## Service Bulletin

**Bulletin No:** JC-13-20

**Product Type:** CRZ Mowers

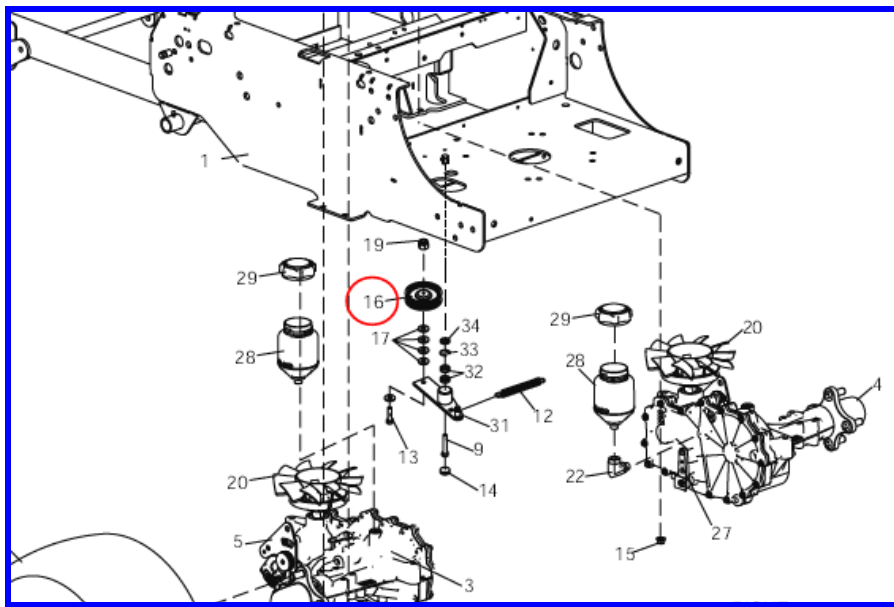
**Customer Issue:** Loss of drive

**Cause:** Premature failure of Pump Idler (bearing fails)

**Action Required:** Replace original Nylon Idler (part # 4168218) with metal Idler (part #2228016). Also supersede 4168218 to 2228016 in your parts department.
